POLYPROPYLENE TAILPIECE ASSEMBLY

SUBMITTAL IDENTIFICATION SHEET

WEBSTER UNIVERSITY ISB
PROJECT NAME

123553-001 REV 2
CONTRACTOR / CM SUBMITTAL NO.

Drawing Number: 9976WS - 102084

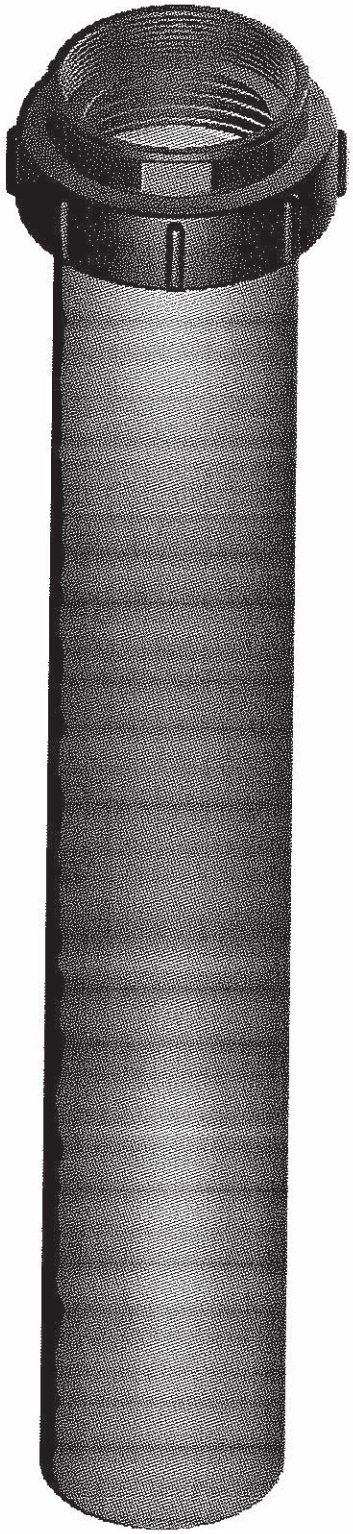
COORDINATE WITH PLUMBING DOCUMENTS.

PLUMBING TO REVIEW
